Notice is hereby given according to State Statutes that the SITE REVIEW COMMITTEE of the Village of Hobart will meet on **Thursday May 28th 2026**, at 5:30 P.M. at the Village Office (2990 South Pine Tree Road). NOTICE OF POSTING: Posted May 22nd 2026, at the Hobart Village Office and on the village website.

MEETING NOTICE – SITE REVIEW COMMITTEE

RE: 1130 Orlando Dr., HB-332-3-1; 16,945 SF Indoor Riding Arena/Barn w/ Associated site Improvements

ISSUE: Discussion and action to consider a new 16,945 SF Indoor Riding Arena/Barn w/ Associated site Improvements

A200

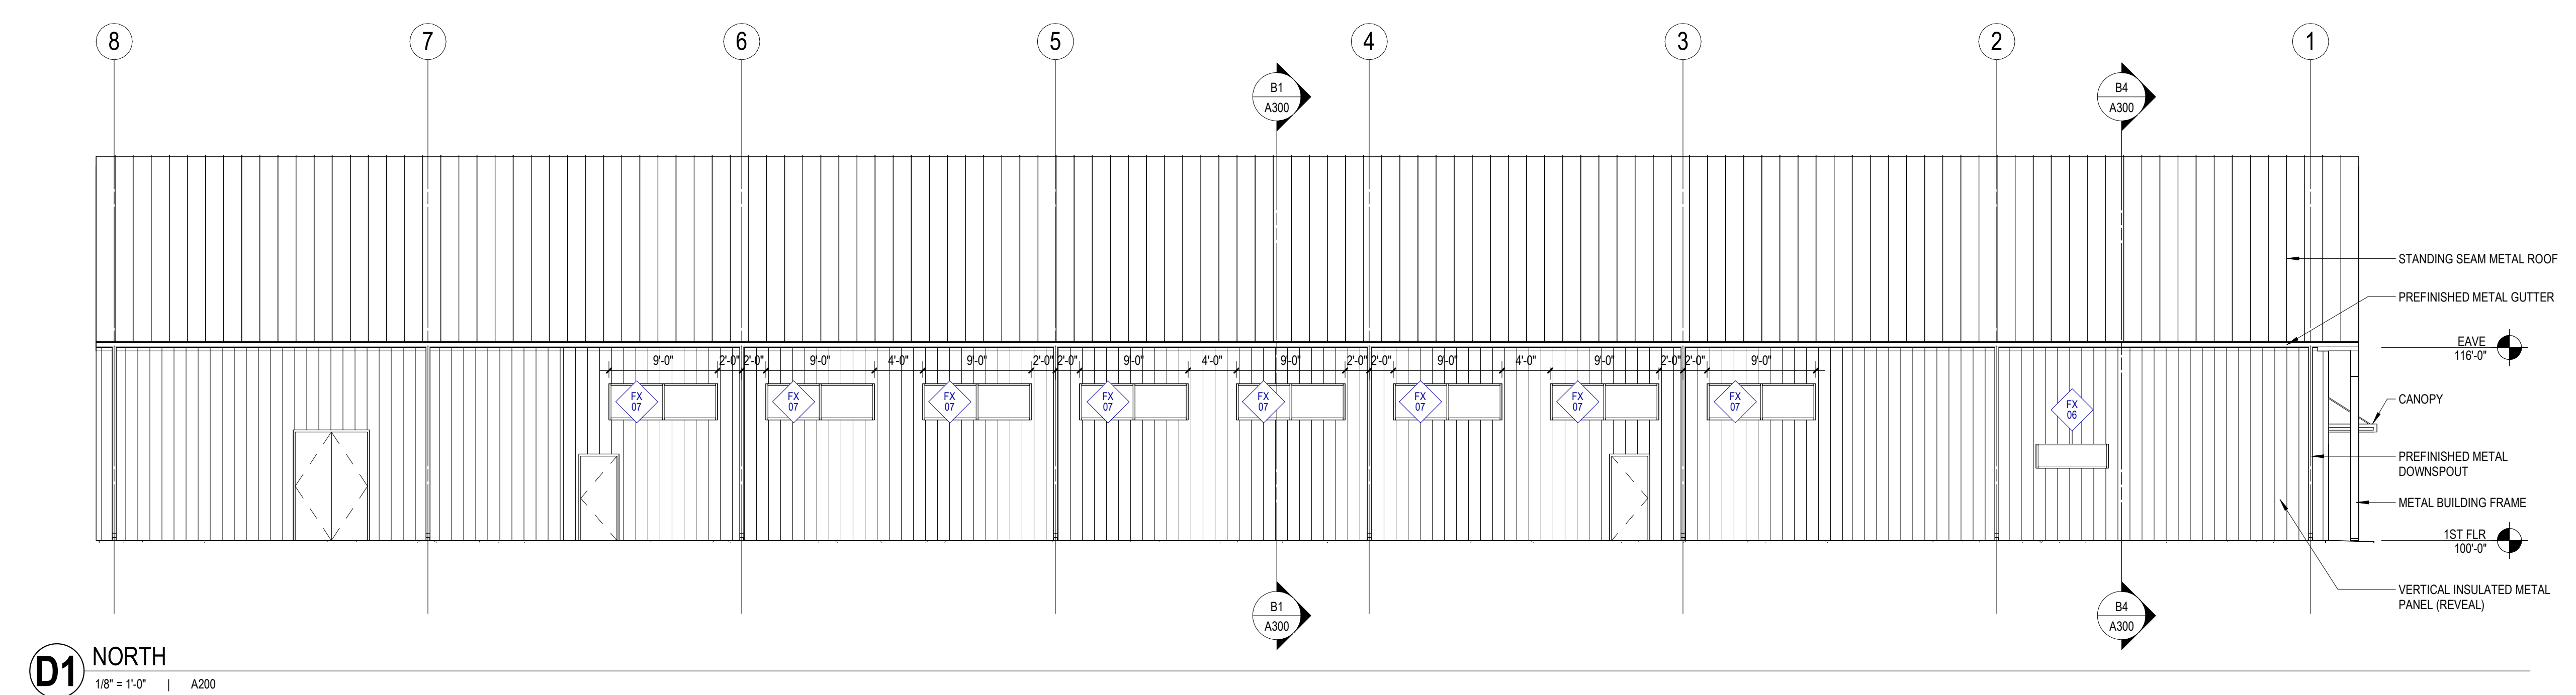
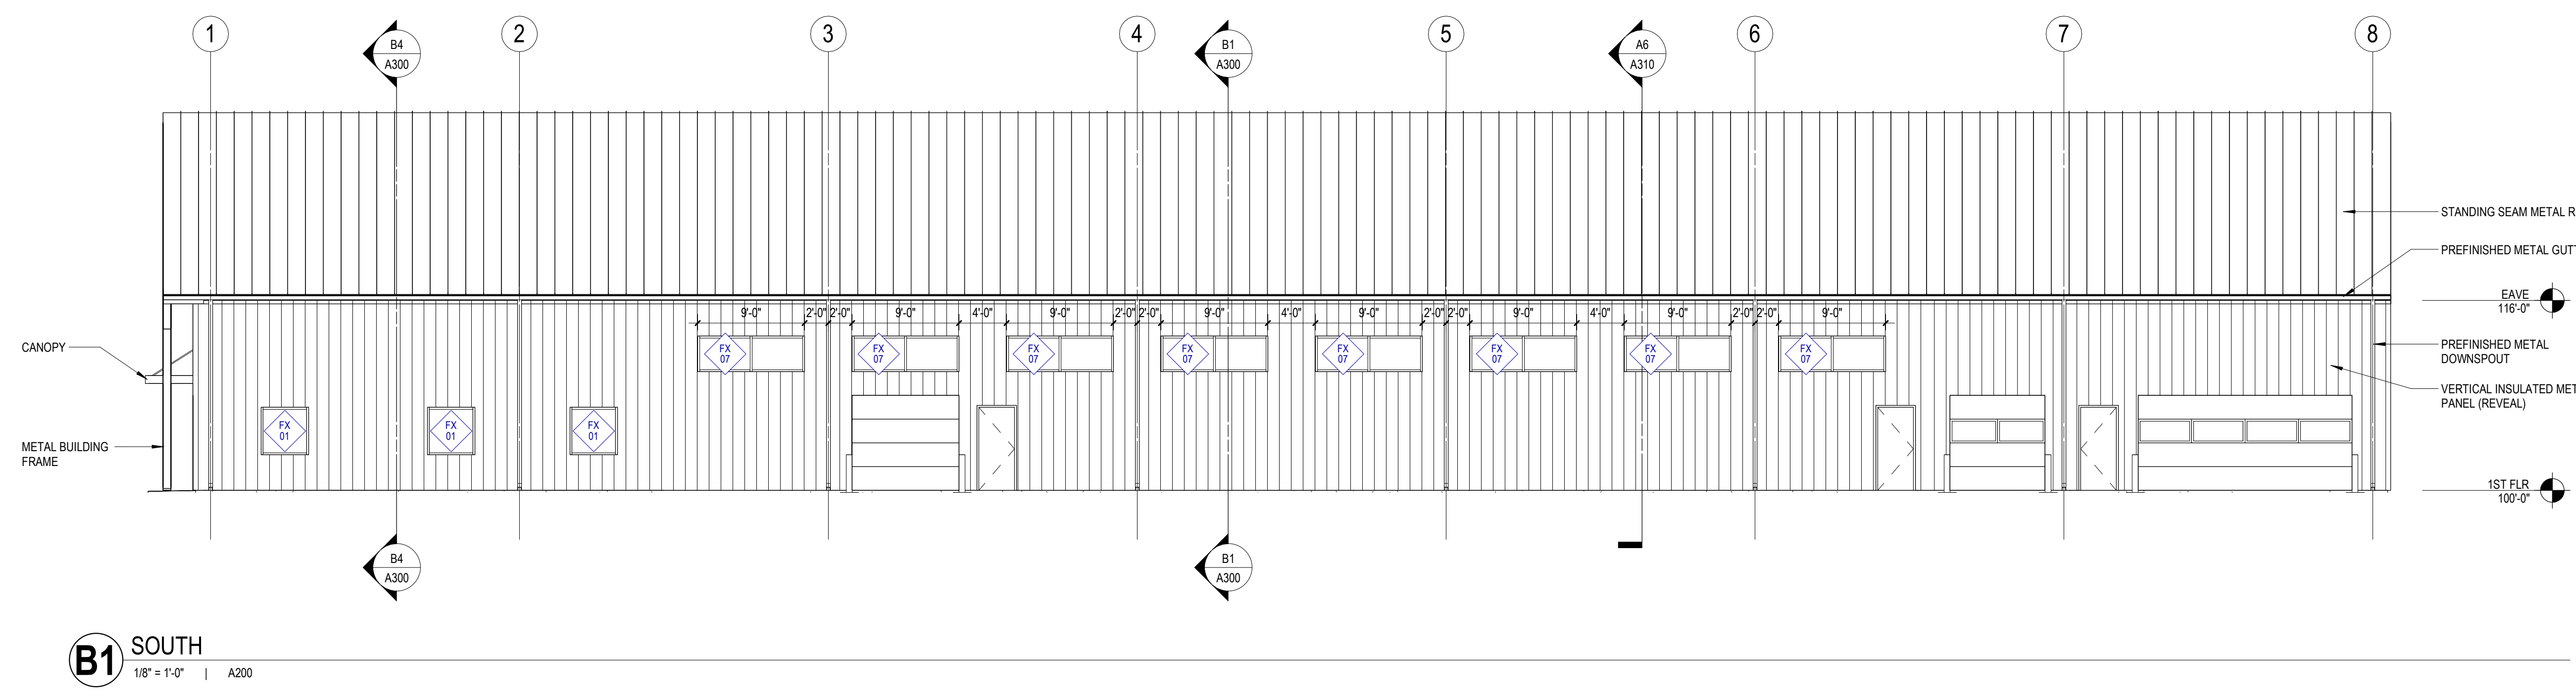
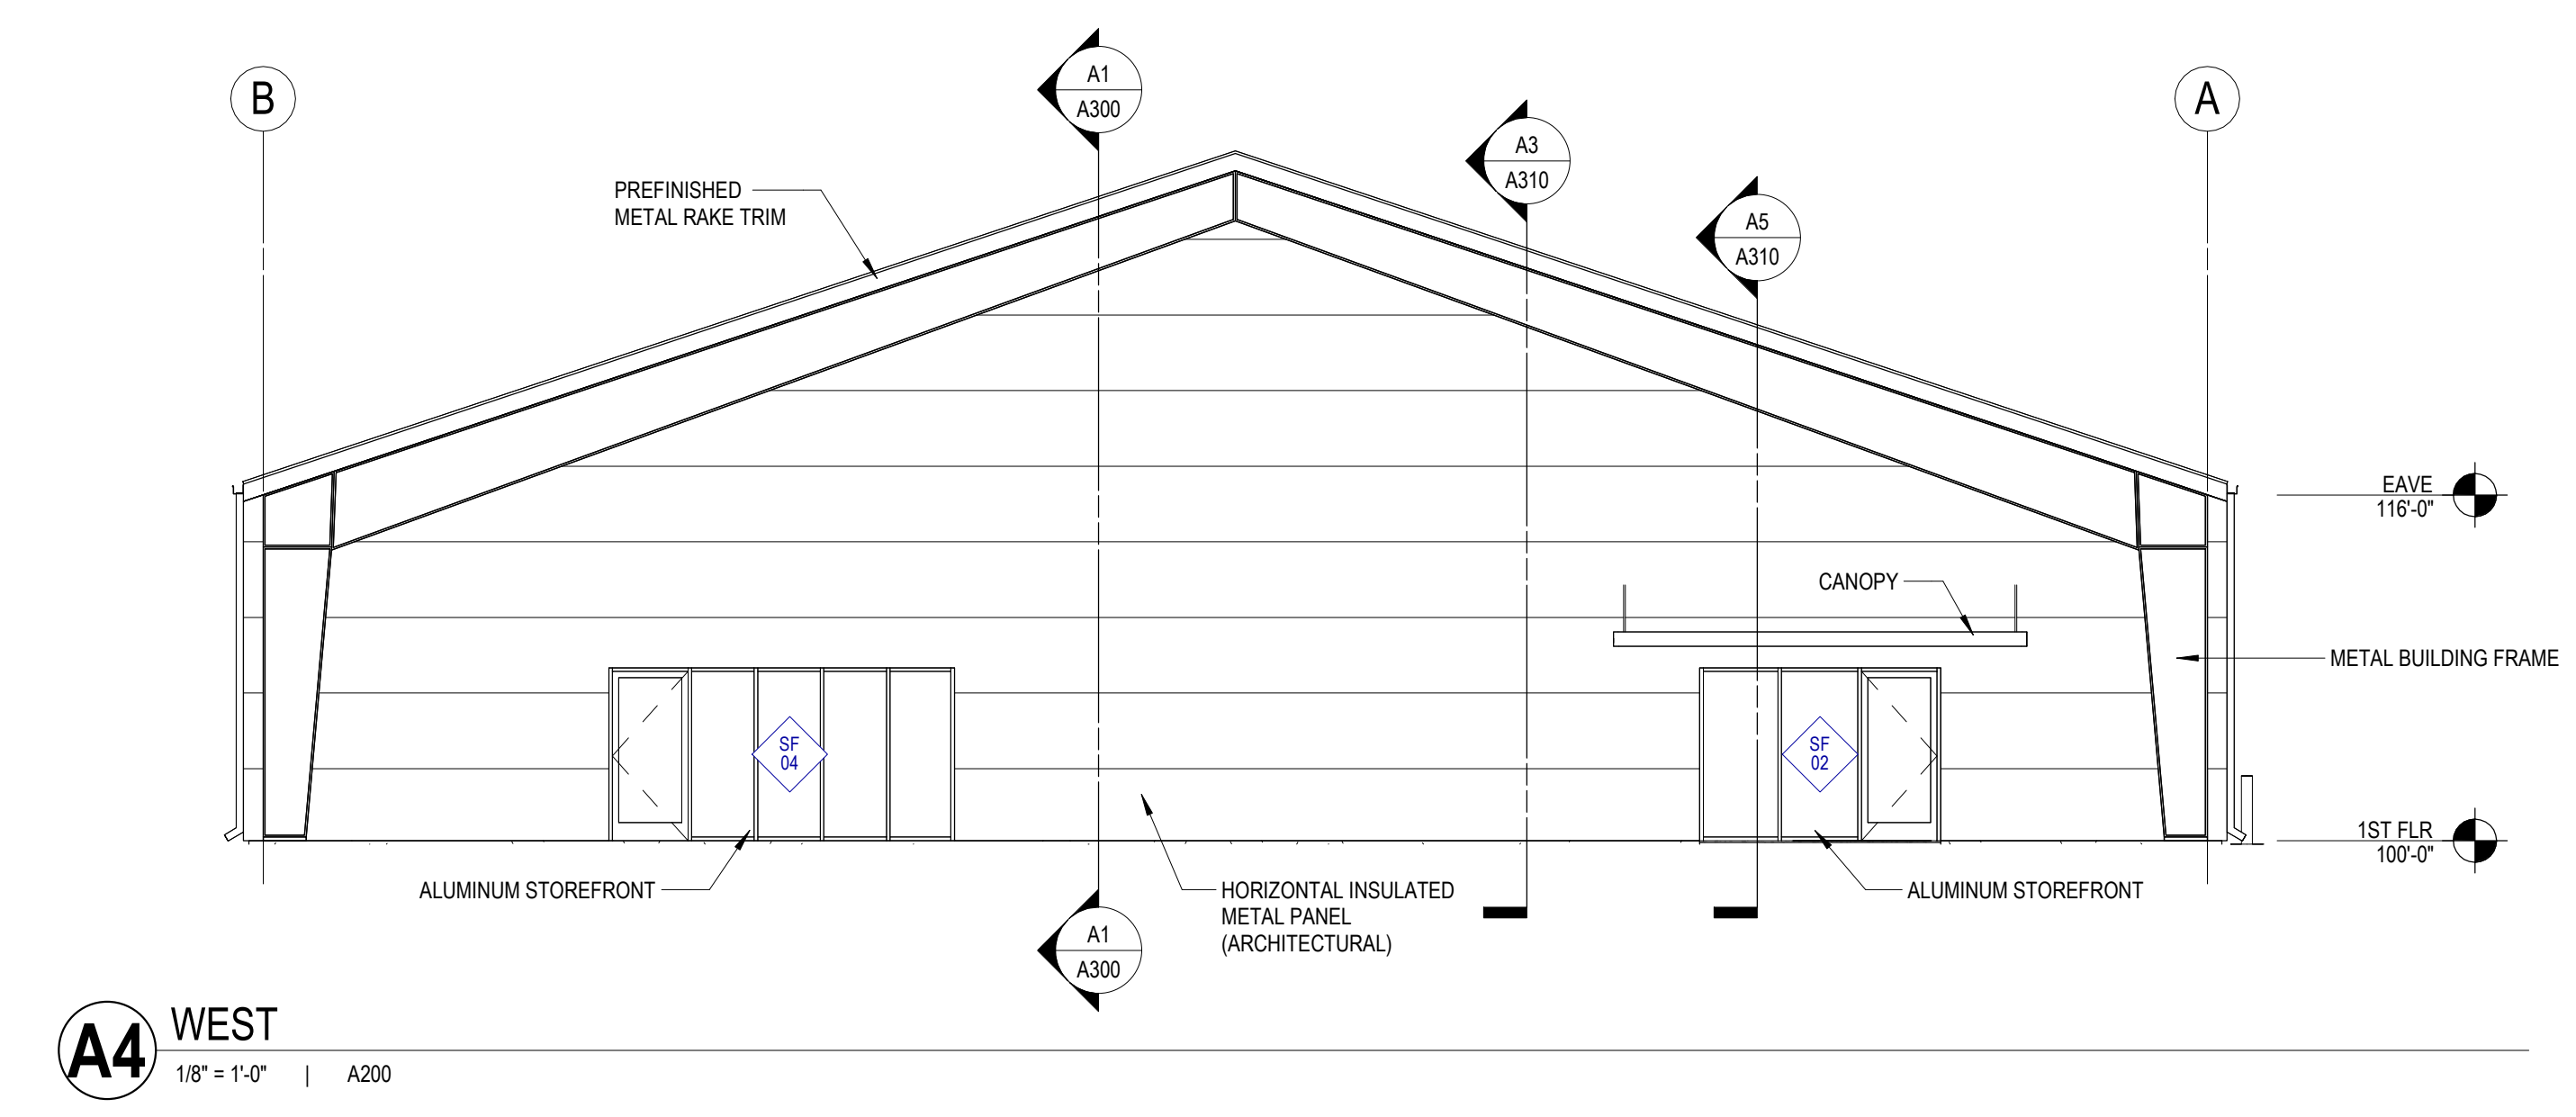
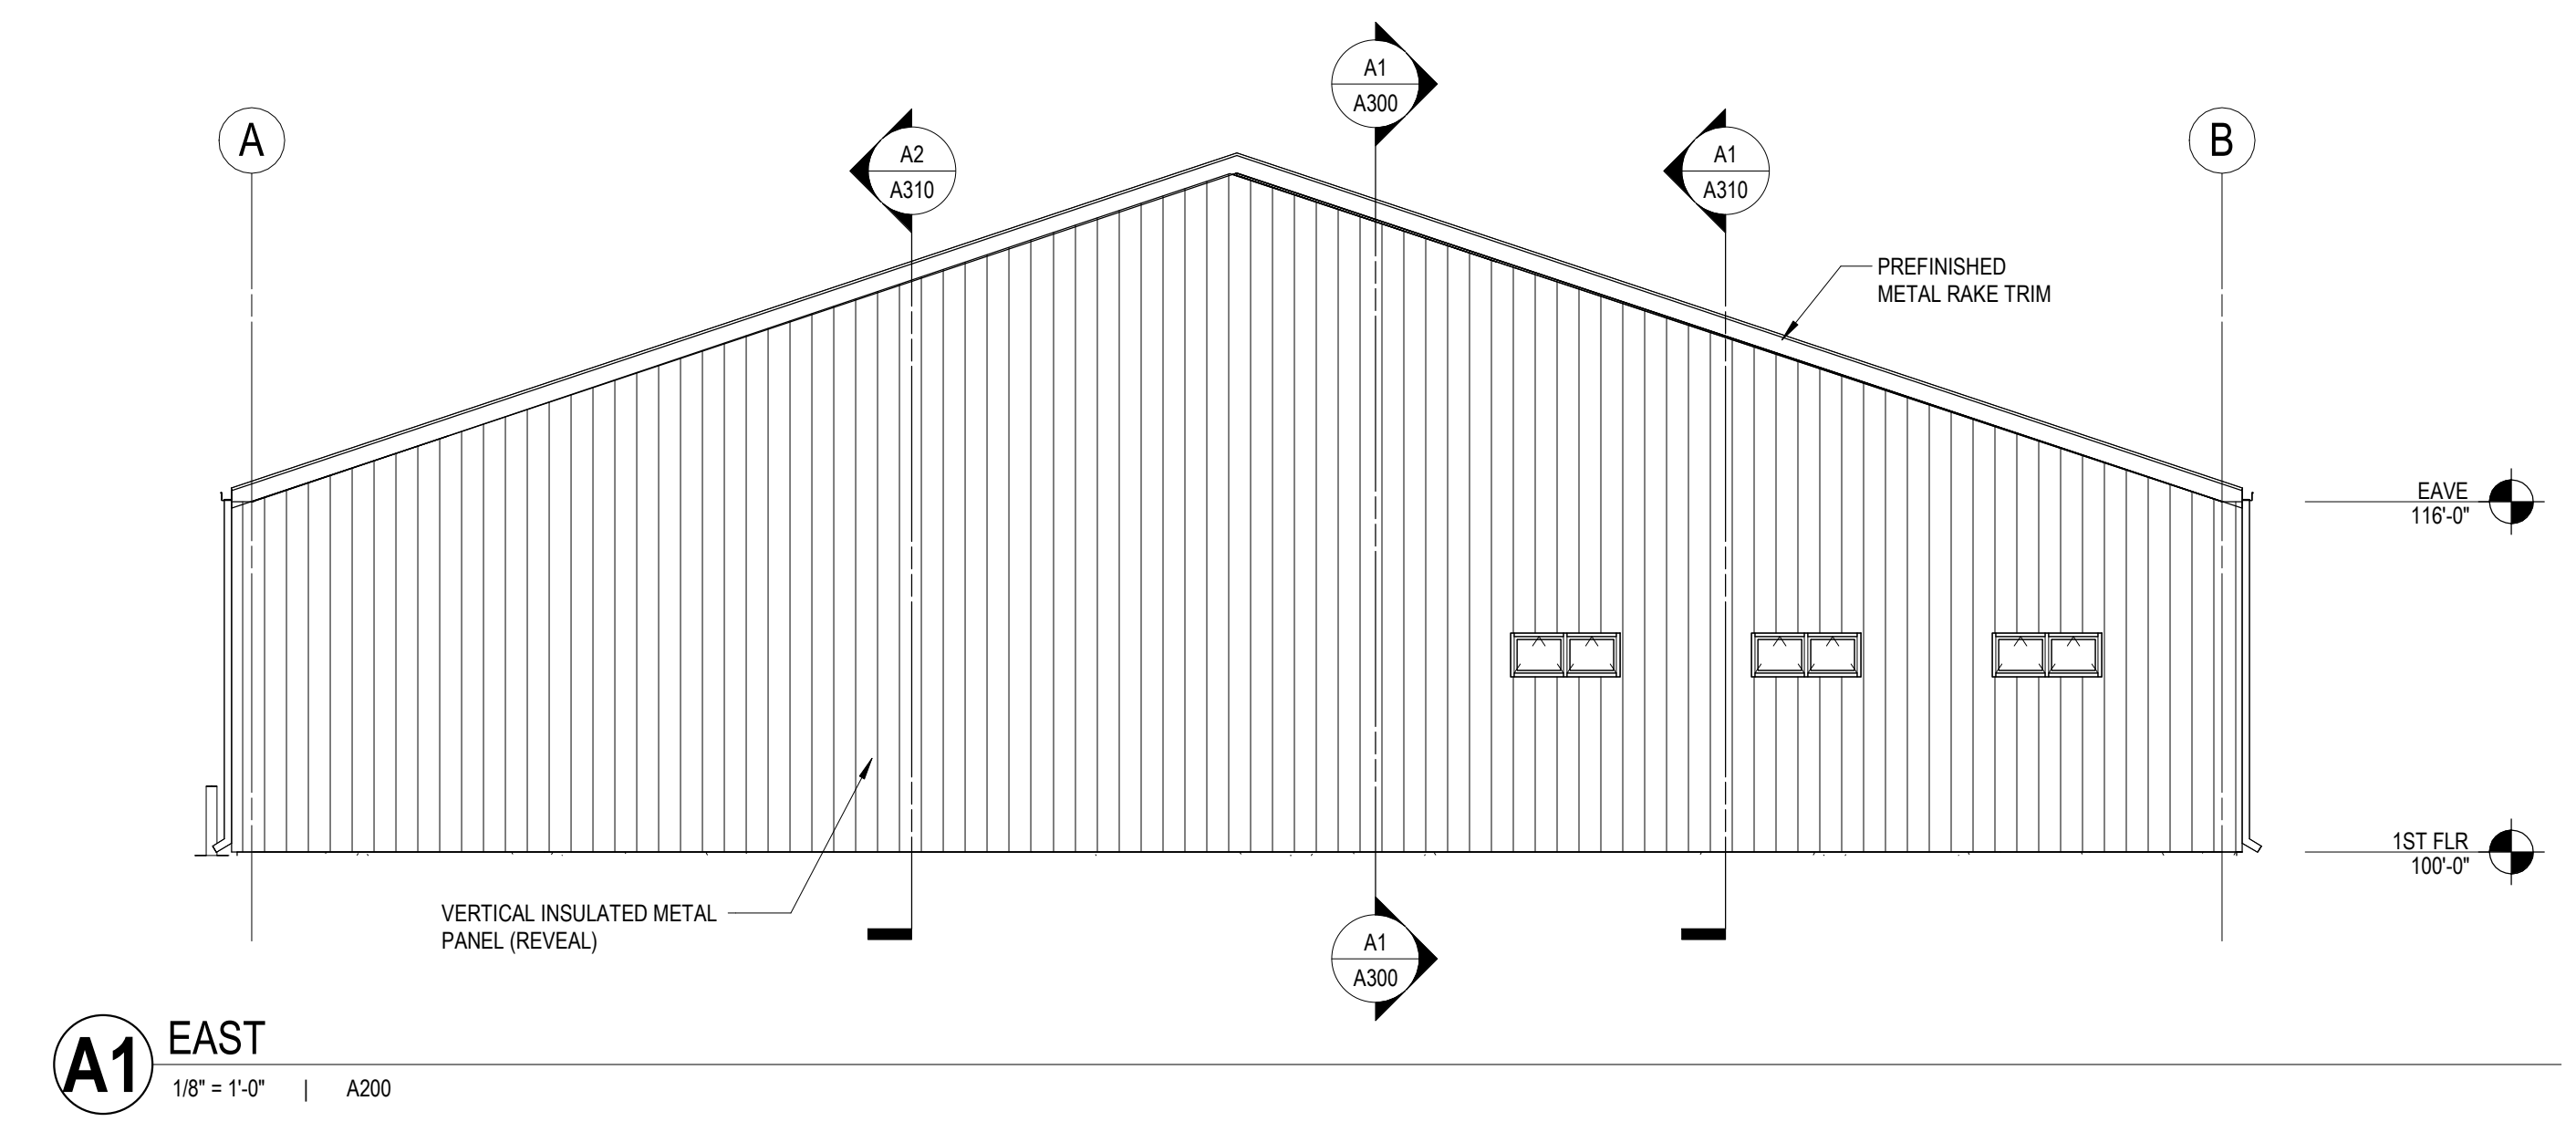
- 1. Materials:** Wood frame buildings.
- 2. Exterior Materials:** The walls of the entire building will be IMP panel (3" thick insulated panels that will be all concealed fastener). The main entrance elevation will be horizontal panels while the remaining elevations will be vertical panels.
- 3. Height:** Anticipated at 34 feet to the roof ridge (16' to eave)
- 4. Overhead doors:** There are two overhead doors on the south elevation to allow access to the stable area and the arena area.
- 5. Mechanical equipment:** None noted on the plans, but all such equipment shall be screened from view with materials to match those of the principal structure or with landscaping. All exterior exhaust/intake vents shall be colored to blend with the principal structure.

Section 5, Signage: The signage noted on the building elevations exceeds the limits of the Village Sign Code. Therefore, any proposed signage shall be required to be submitted for approval at a later SRC meeting prior to installation.
